## NOTICE OF APPROVAL

**Planning Case #:** Design Study 23229

**Project Description:** This approval of Design Study (DS 23-229, Nelson) authorizes a partial after-the-fact approval for amendments to previously approved design studies (DS 19-489, DS 19-054) for alterations at an existing single-family residence with an active building permit (BP 20-260) located on Guadalupe 4 SW of 2nd the Single Family Residential (R-1) District. The modifications approved under this Design Study include: 1. Revise pathway plan, replace walkway and driveway with Calstone pavers, exterior courtyard door replaced with reused existing window, and revise location of exterior lights. Changes not expressly authorized above are prohibited. The project shall be consistent with the plans application materials dated approved by Community Planning & Building Department on August 28, 2023, unless modified by the conditions of approval contained herein. This approval does not lessen or supersede any previous planning approval associated with the current building permit and associated permit revisions unless expressly authorized by this approval.

Revised Site Plan

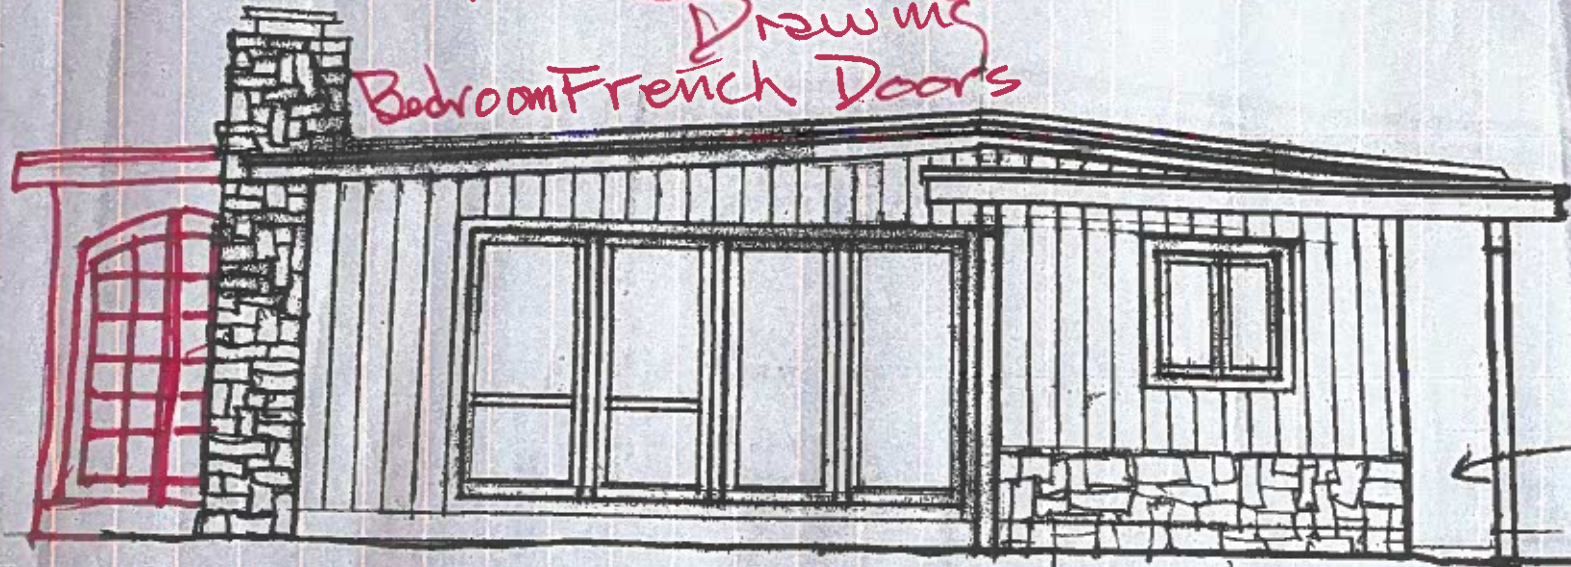
Site Coverage Revised	7.25.23
Paver Driveway total	230.125 <sup>sq ft</sup>
Paver Walkway total	192.0 <sup>sq ft</sup>
Generator Pad	8.0 <sup>sq ft</sup>
Back Stoop	9.0 <sup>sq ft</sup>
Dining Patio	72.5 <sup>sq ft</sup>
Existing Deck (North Side)	62.0 <sup>sq ft</sup>

**EAST ELEVATION - EXISTING**

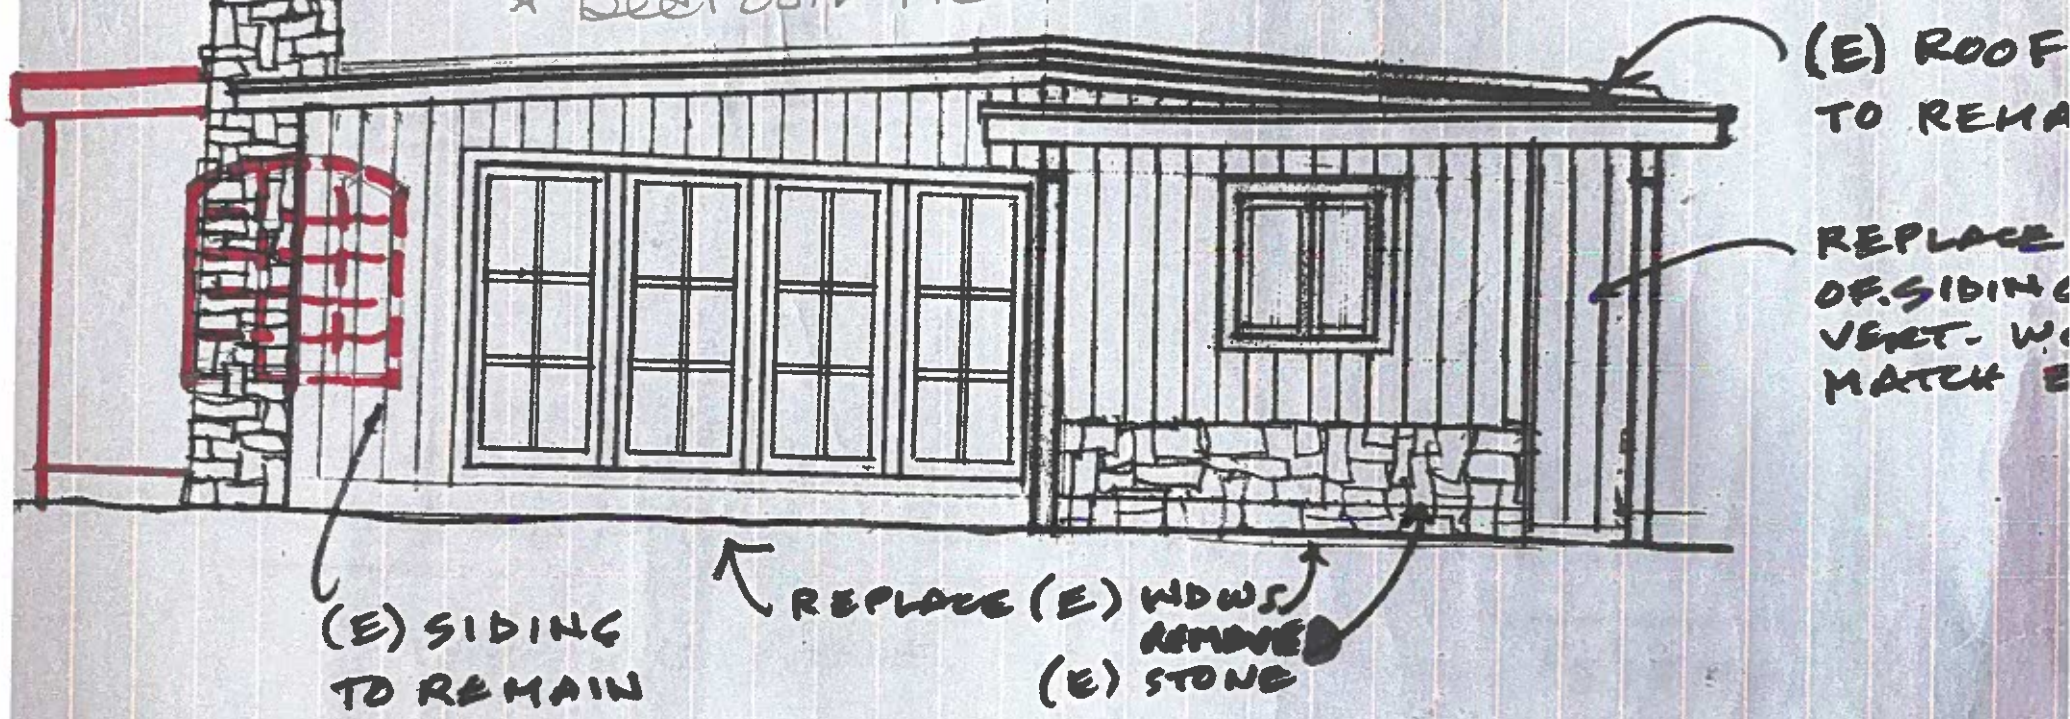
Missed on Original  
Drawing  
Bedroom French Doors

Red shows Missing on  
Original Drawings  
\* Window Not Seen from Front  
\* Bedroom Not Shown

ReUsed old Bath Window  
Replaced French Doors  
to Master Bedroom from  
Patio
